APPROVED
Limited building only review.
Permit holder responsible for full compliance with the code.

Jerry/Jodie Brock
Neill's Creek Road
Angier, NC

FLOOR PLAN
 SCALE: 1/4" = 1'-0"
 FIRST FLOOR HEATED AREA: 3665 SQ. FT.
 GARAGE AREA: 923 SQ. FT.
 FRONT PORCH AREA: 168 SQ. FT.
 REAR PORCH AREA: 443 SQ. FT.
 SIDE PORCH AREA: 111 SQ. FT.

REAR ELEVATION
SCALE: 1/4" = 1'-0"

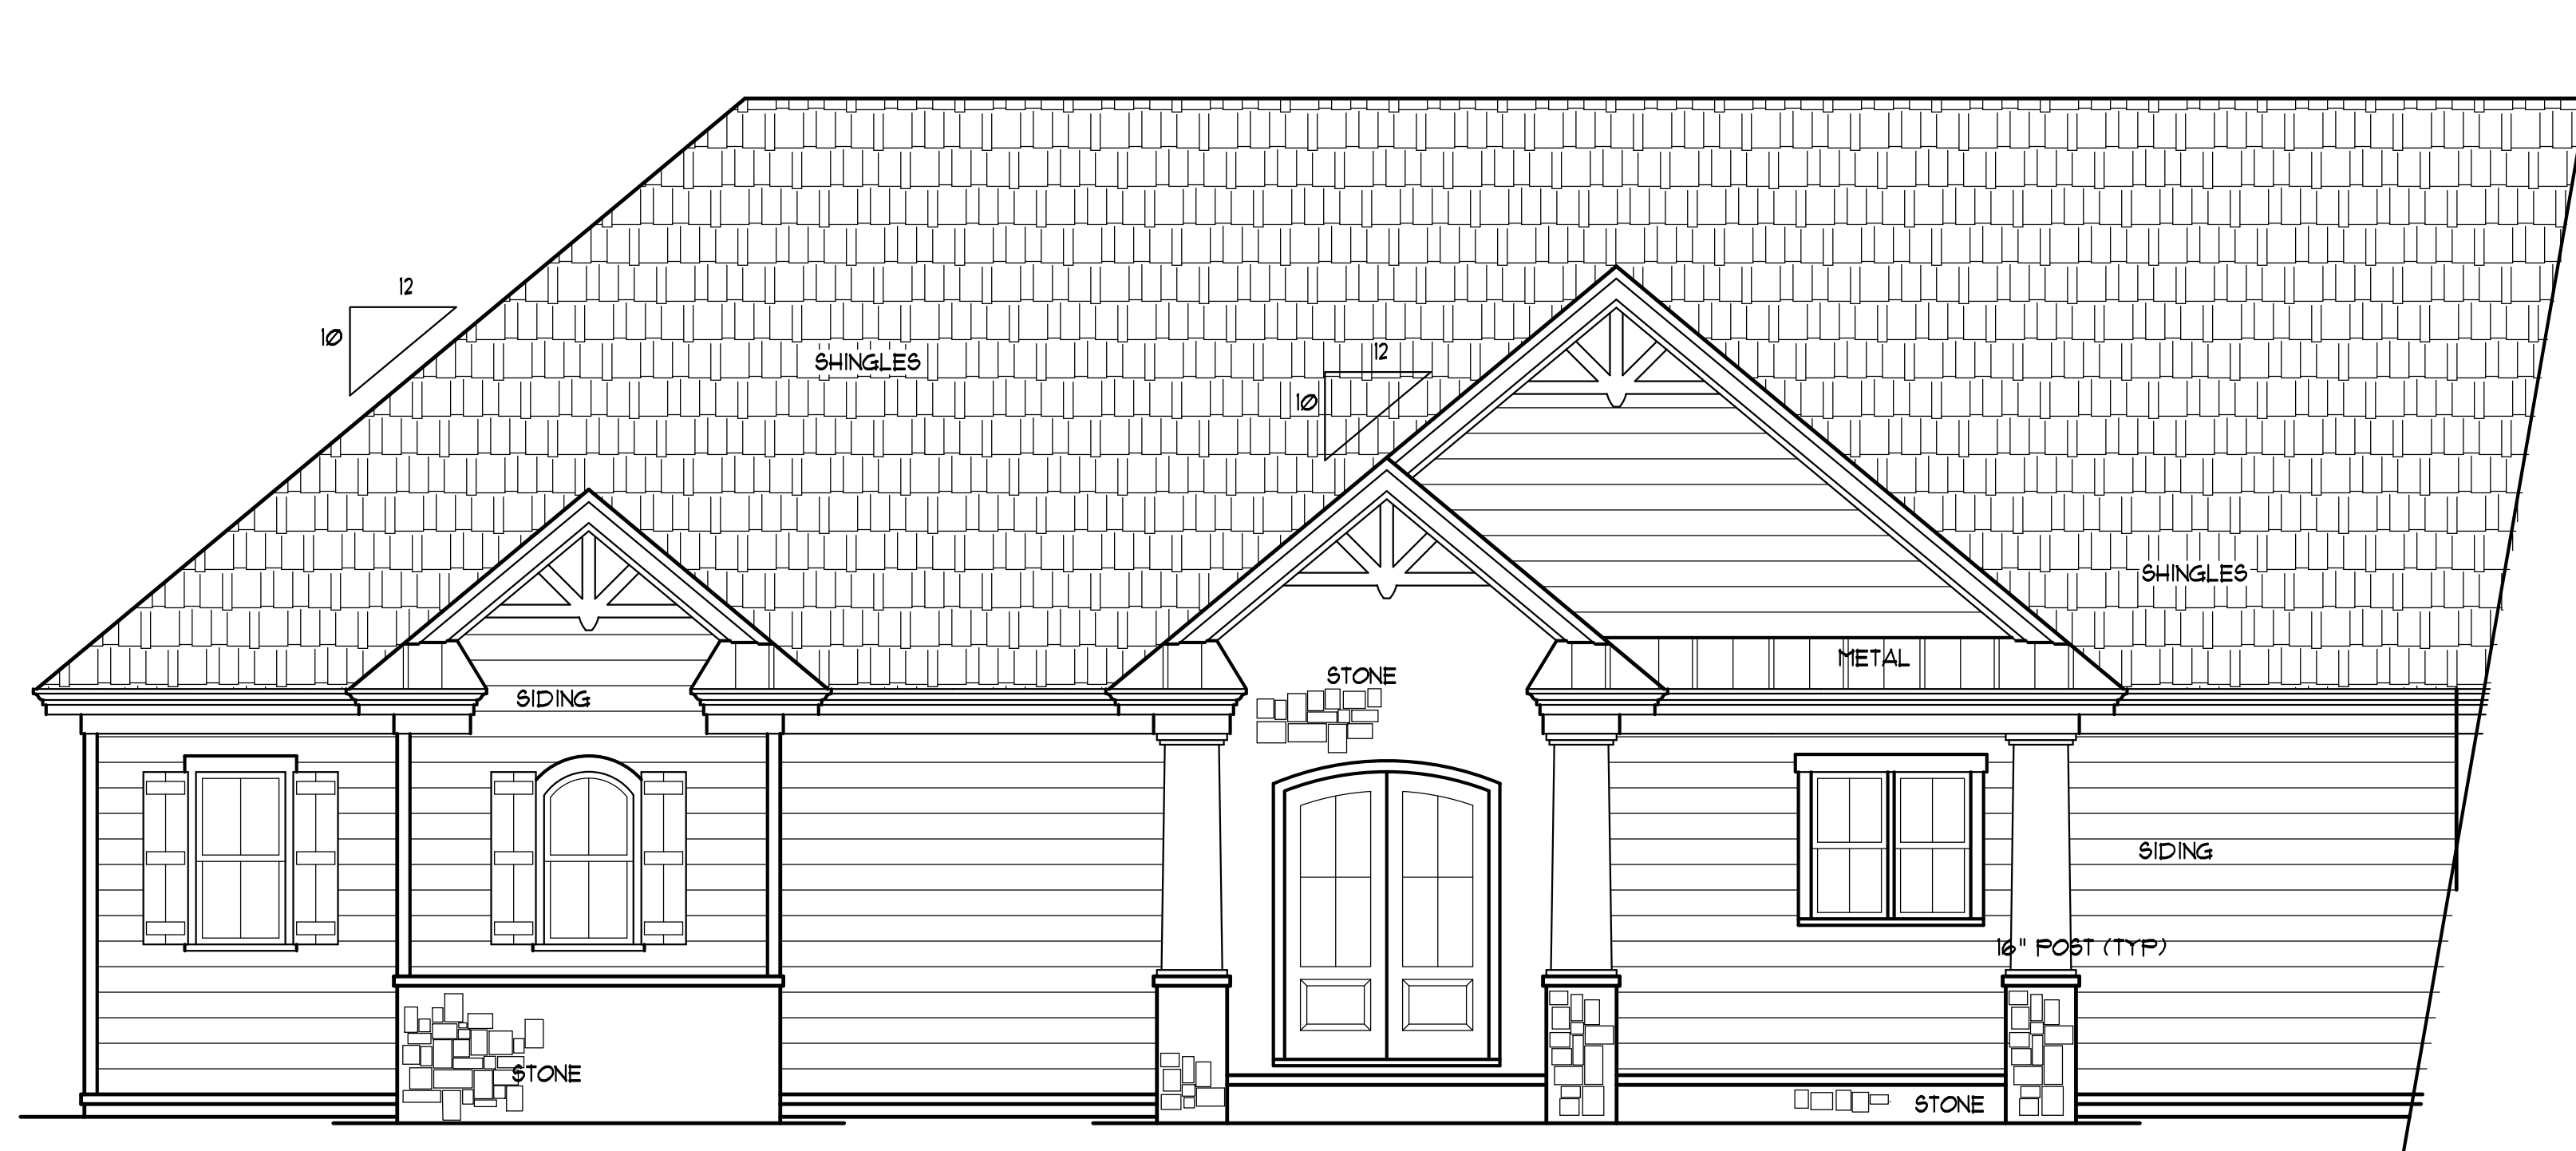
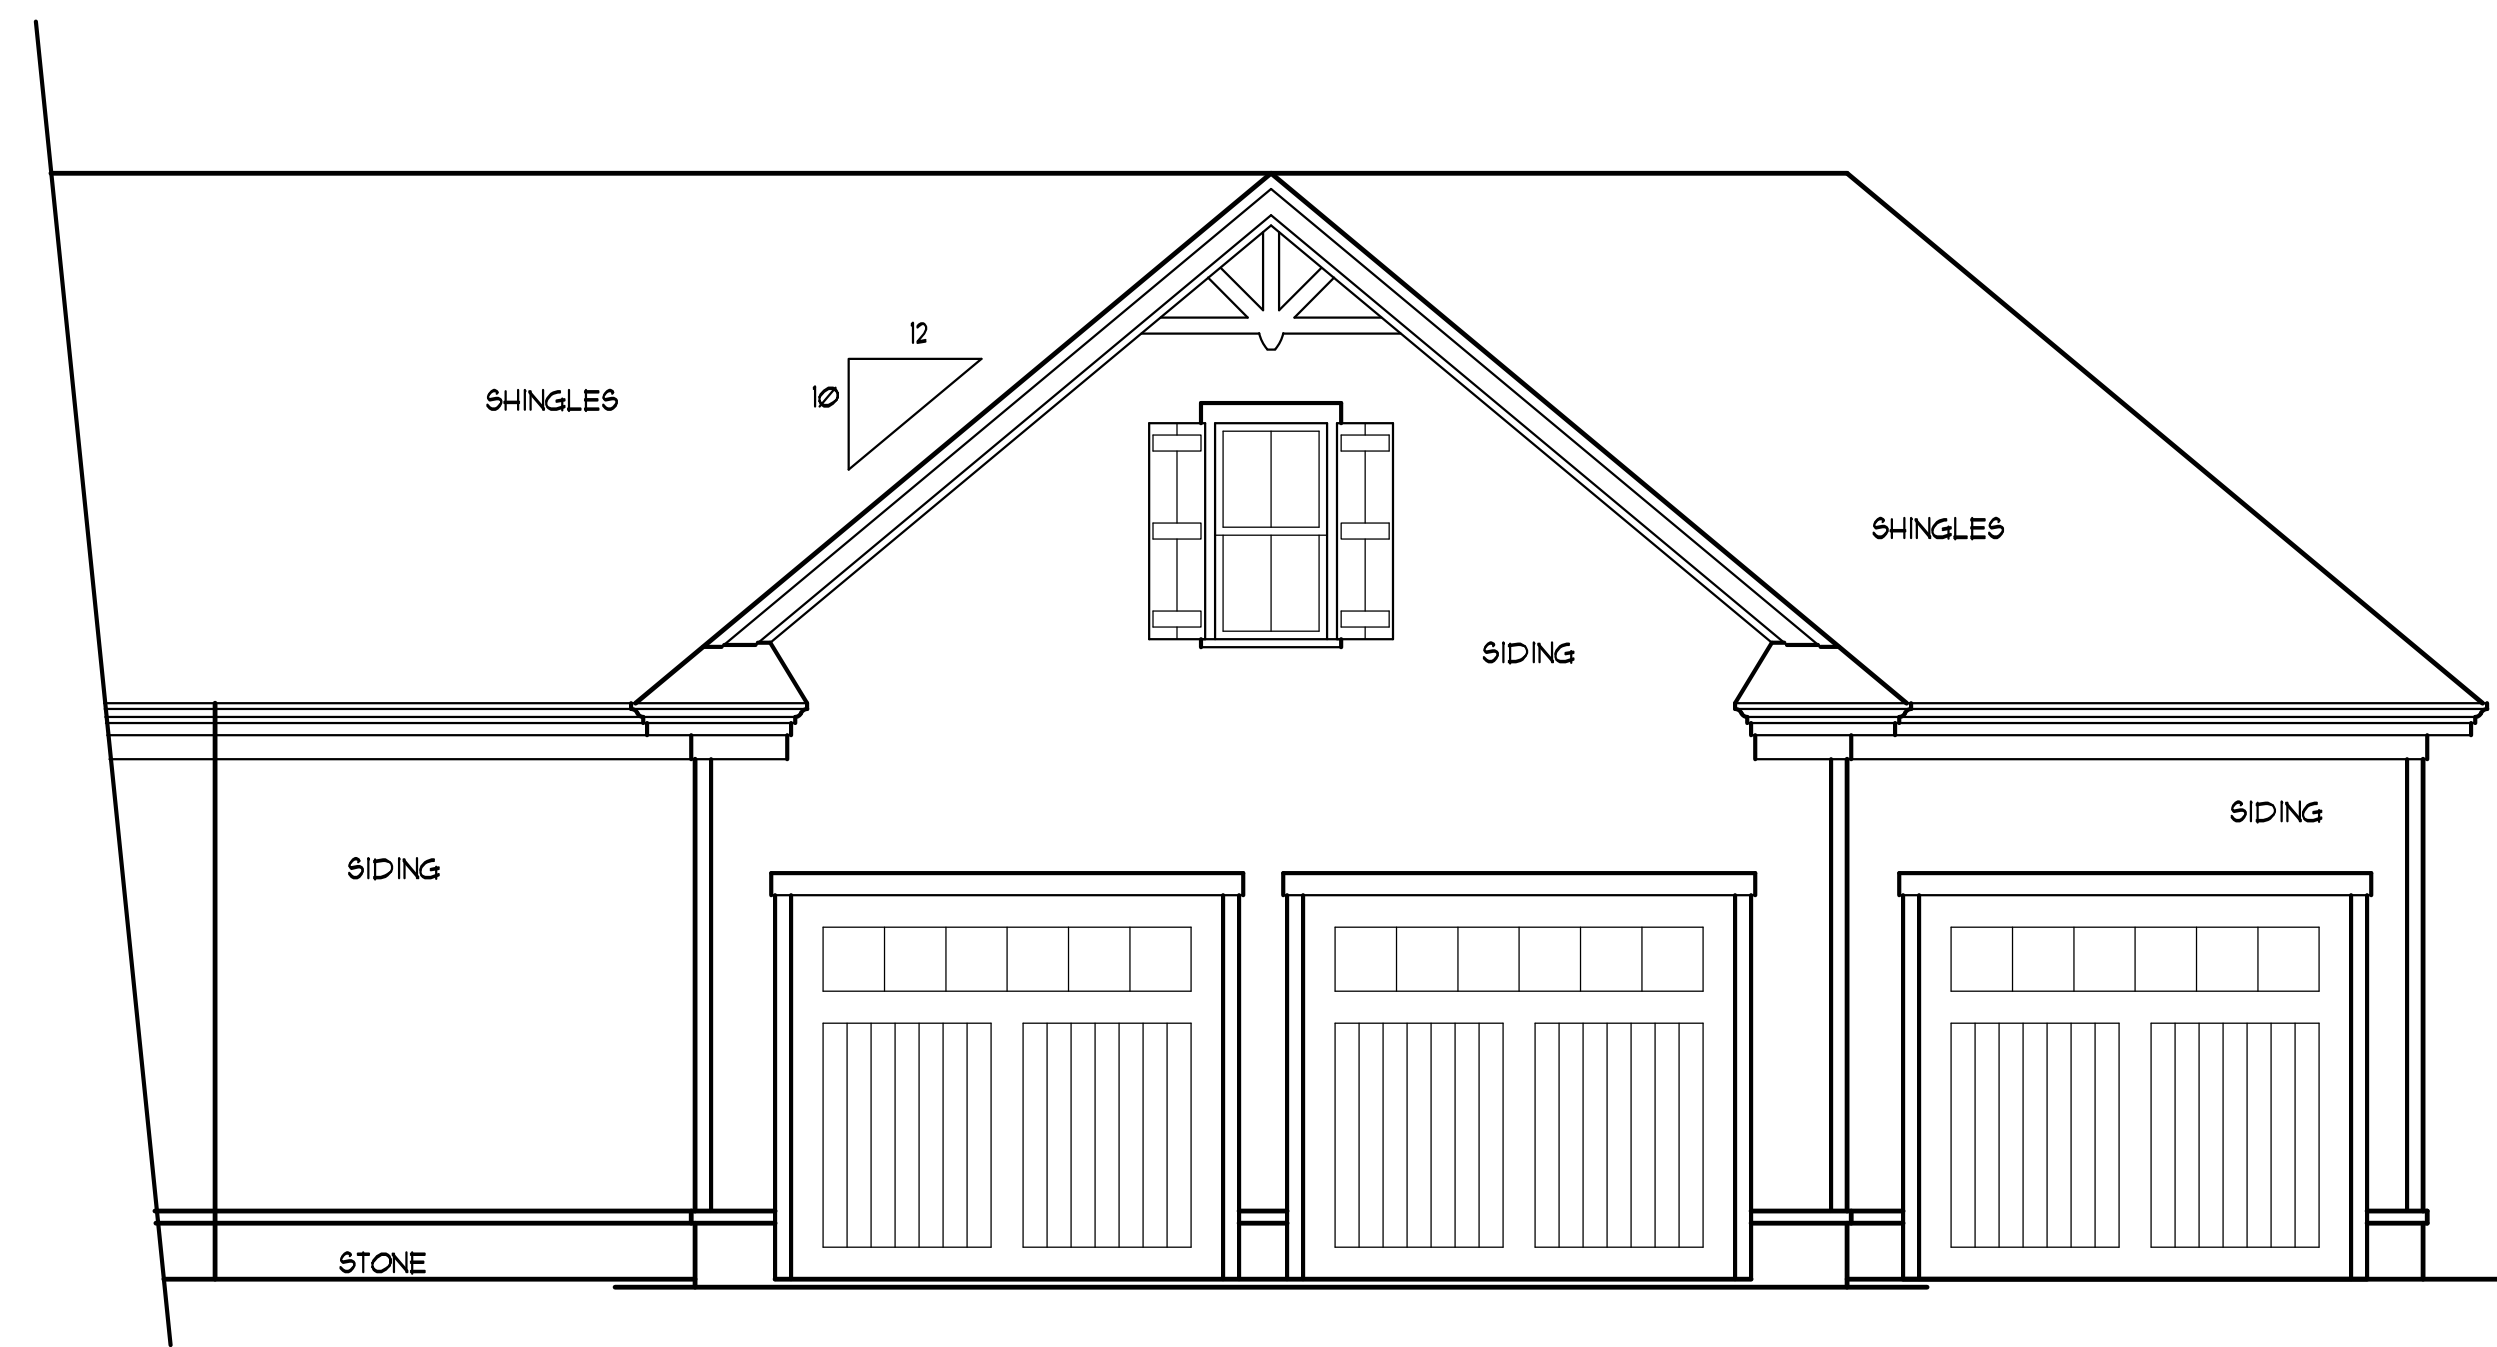
See notes on floor plan. Windows shown in bedrooms will not meet egress requirements. Field verify correction

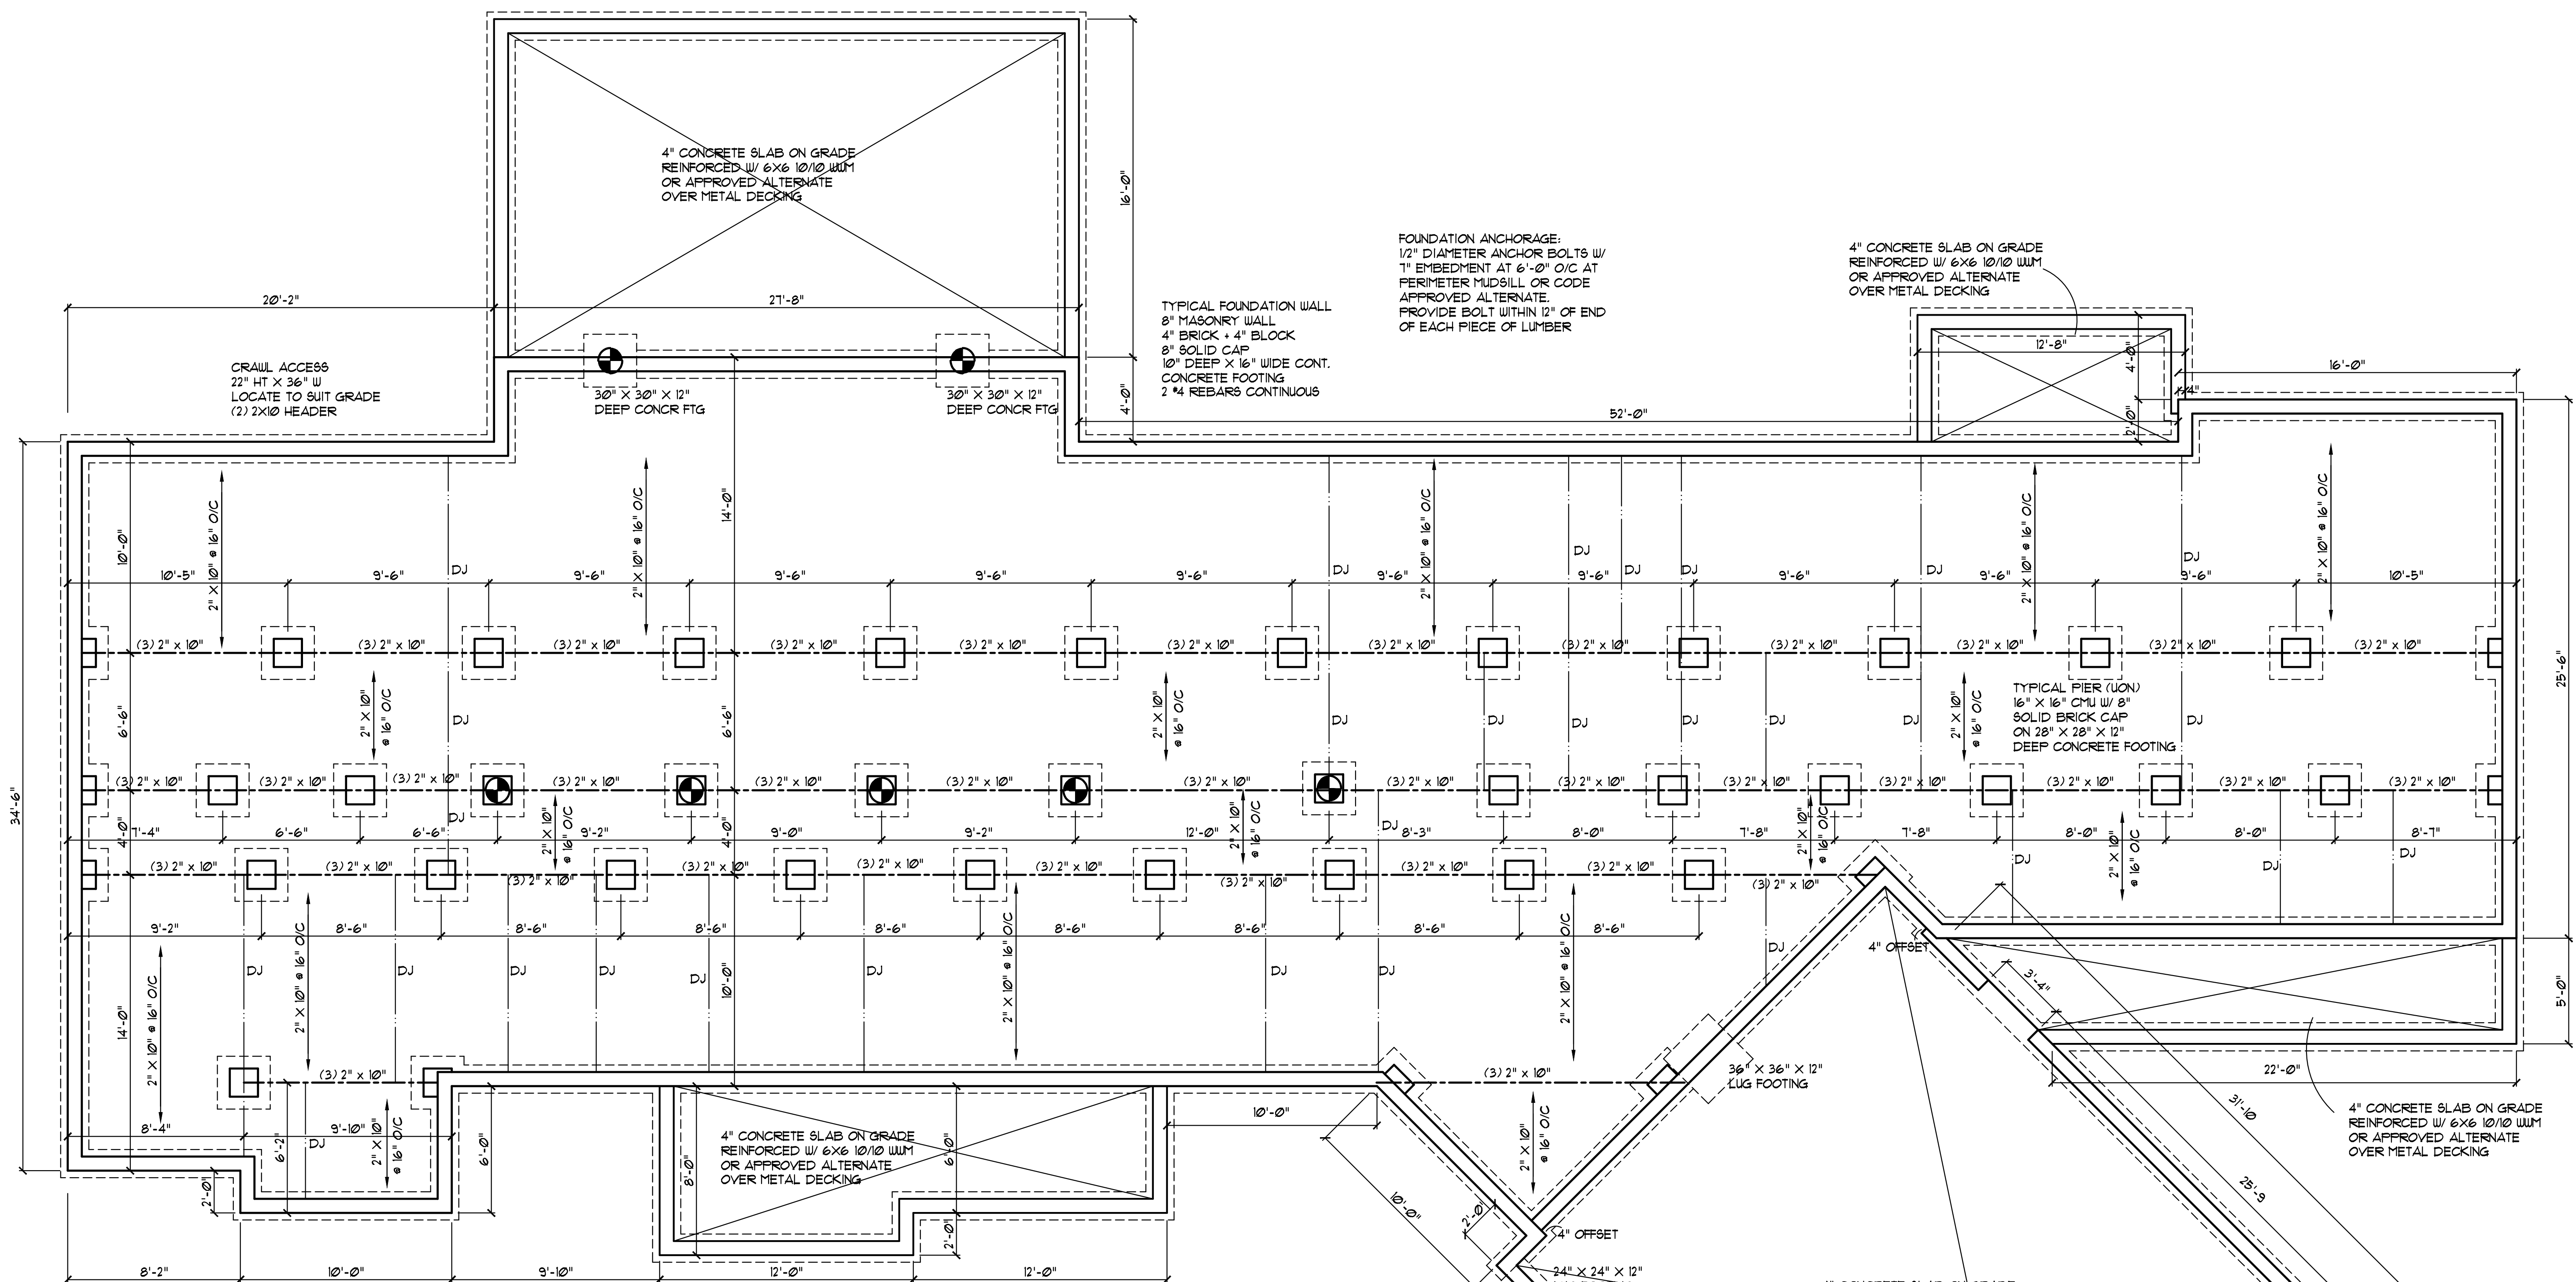
These windows will not meet egress requirements
